**SUBJECT: Seneca Army Depot Activity, Response to Comments on Draft Final Decision Document for the Inhibited Red-Fuming Nitric Acid (IRFNA) Disposal Sites (SEAD-13)**

**Subject:** Draft Final Decision Document for SEAD-13  
Seneca Army Depot  
Romulus, New York

**Subject:** Draft Final Decision Document – Mini Risk Assessment for the Inhibited  
Red Fuming Nitric Acid (IRFNA) Disposal Site (SEAD-13)  
Seneca Army Depot  
Romulus, New York

FIGURE 2-6  
 SEAD-13 IRFNA Disposal Site  
 Groundwater Elevation Plan  
 April 2002

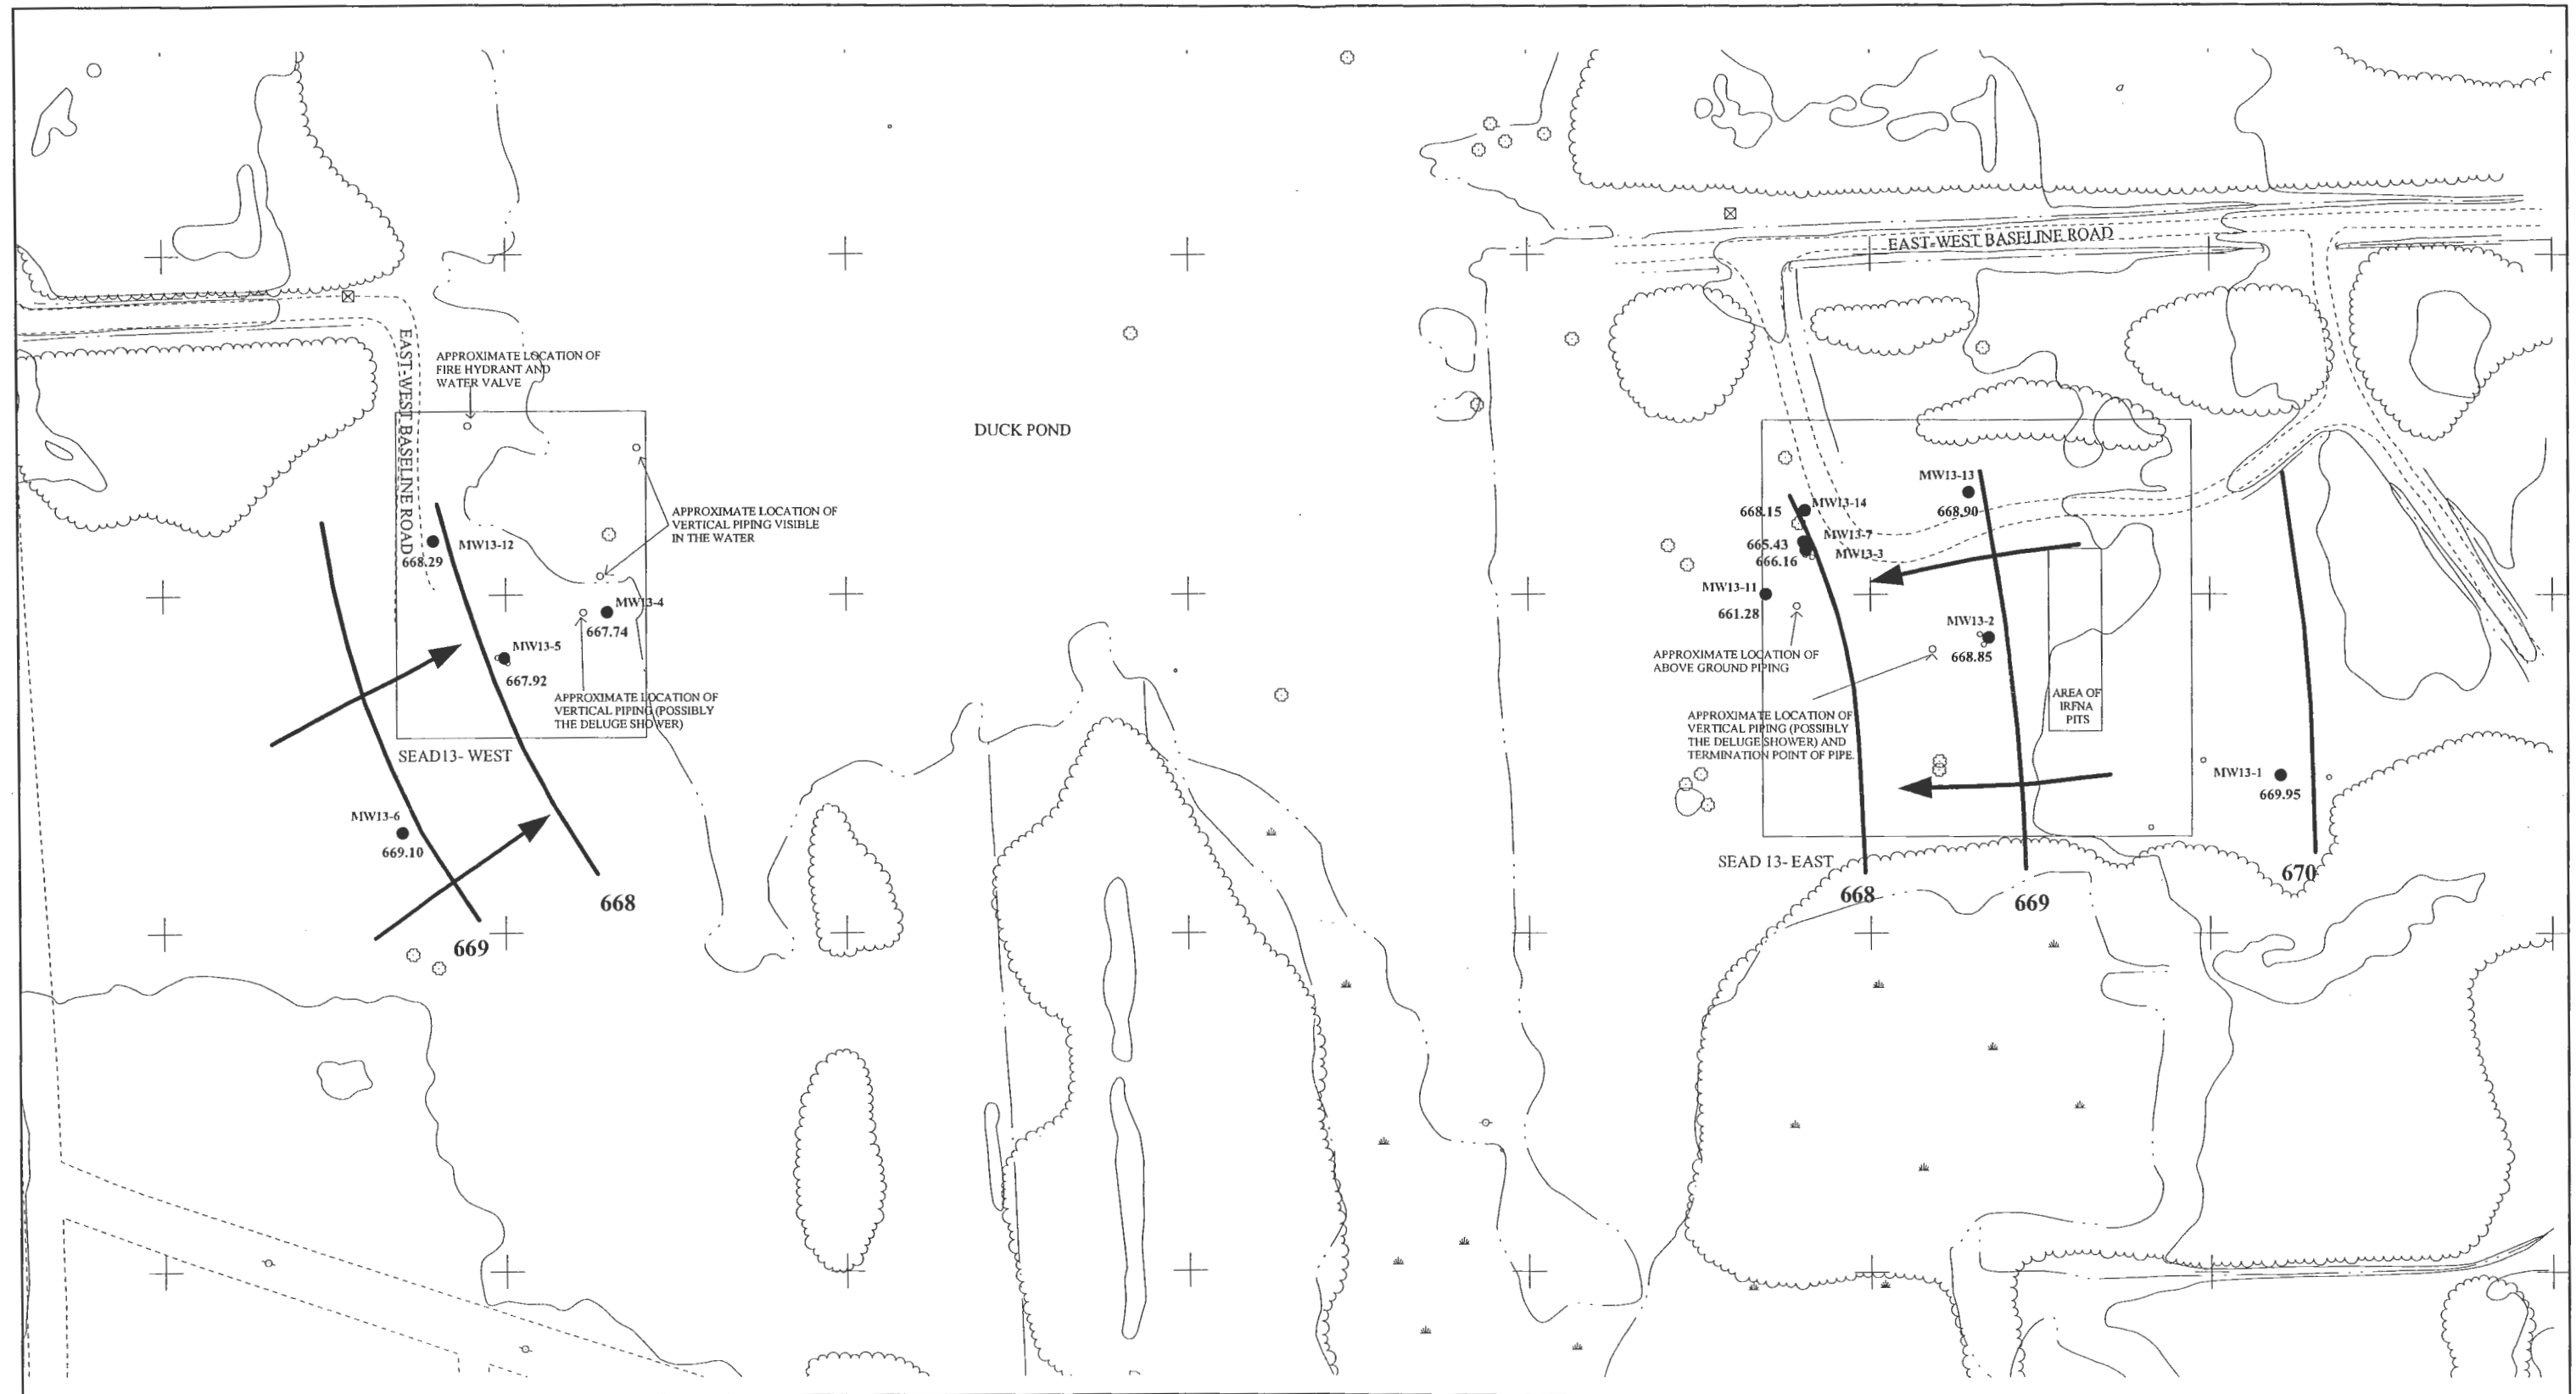
**Comment 2:** Page 2-5, Section 2.4.3, Groundwater: This paragraph indicates that for SEAD-13-West, monitoring well 13-(1)2 is upgradient and monitoring well 13-6 is a downgradient well. The paragraph also indicates that the presumed direction of groundwater flow was to the northeast for SEAD-13-West. Based on Figure 2-3, the presumed groundwater

flow is in conflict with the upgradient and downgradient designations for the wells. Revise accordingly.

**Comment 14:** Figures 2-1 through 2-7: On these figures it is unclear where the suspected IRFNA pits are on the west side of the site. Therefore it is difficult to support the Army’s location of monitoring wells and sampling points on the west portion of the site. Also, groundwater direction should be indicated where appropriate.

The presumed groundwater flow is now discussed in new Section 2.5.4 and shown on Figure 2-6.

The direction of groundwater flow has been added to a new Figure 2-6. In general, groundwater flows toward the Duck Pond. It should be noted that Figures 2-6 and 2-7 have been renumbered as figures 2-7 and 2-8, respectively.

FIGURE 2-9  
 SEAD-13 IRFNA Disposal Site  
 Plume Delineation

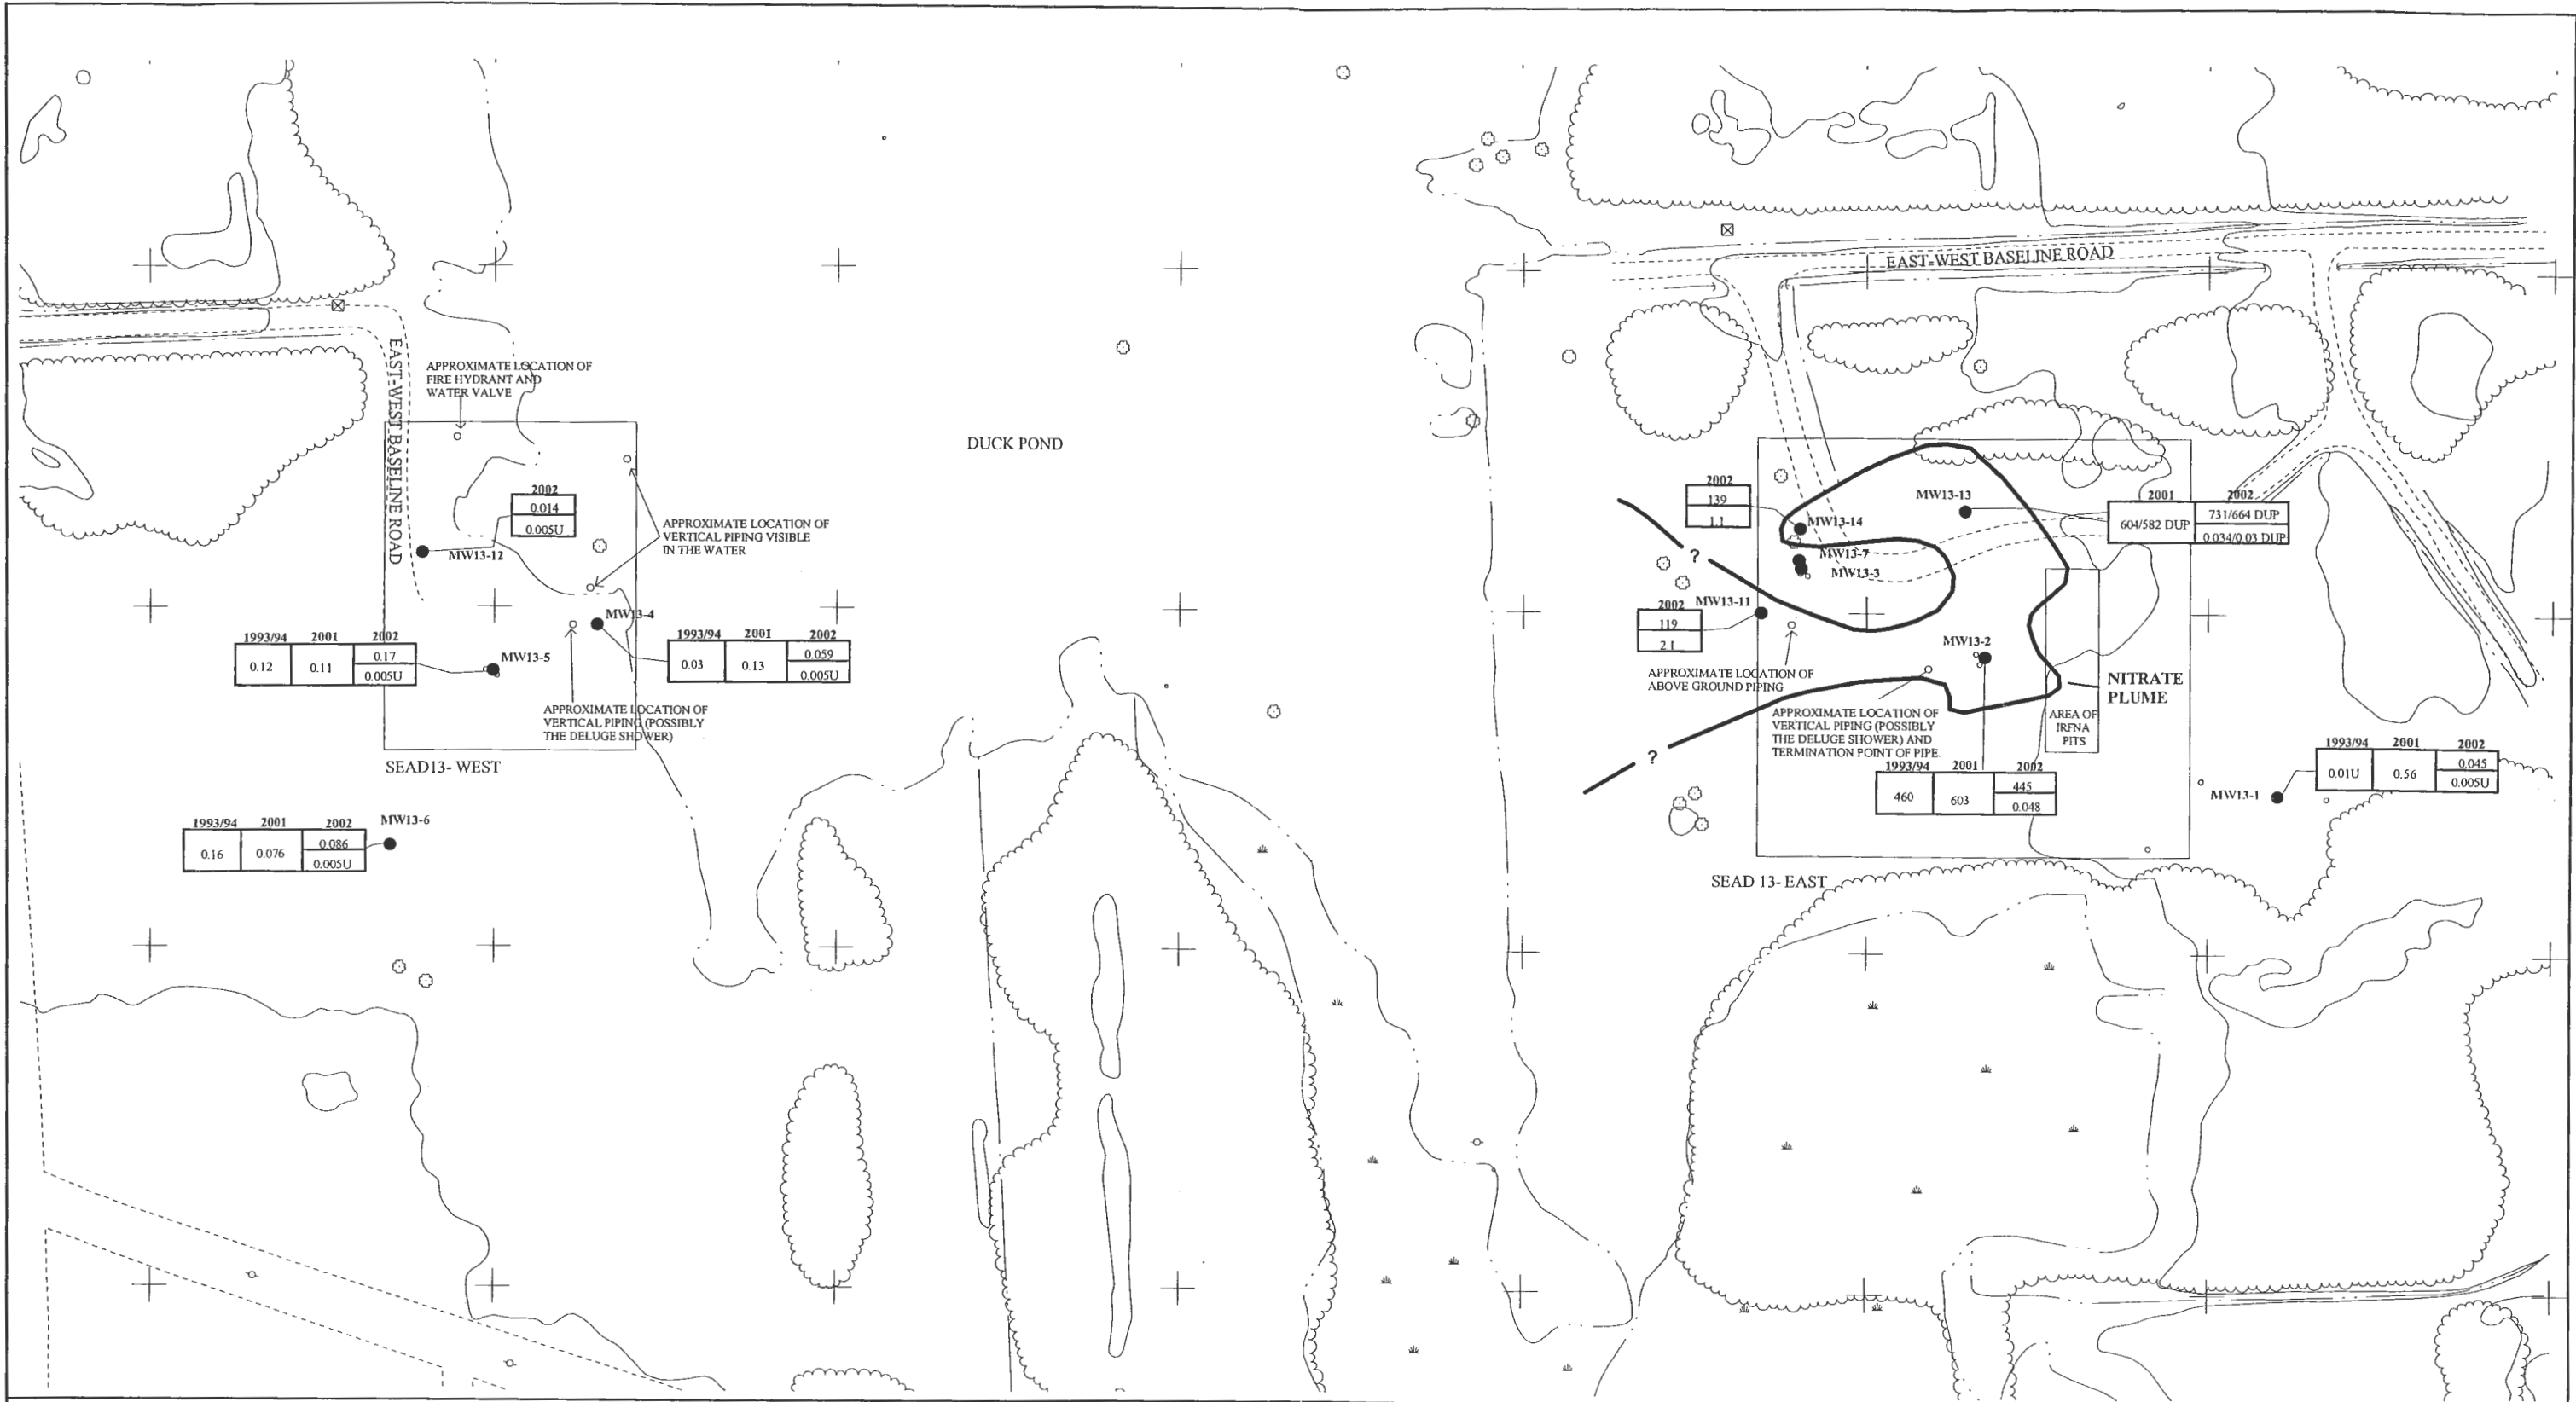
**Comment 6:** Has the groundwater contamination been sufficiently delineated? If so, please provide a plume sketch, depicting both nitrate/nitrite and metals contamination.

**Response 6:** The groundwater contamination has been sufficiently delineated. Figure 2-9 provides a plume sketch, as well as nitrate/nitrite data.

As discussed in Response No. 5, there is no metals plume map to present.
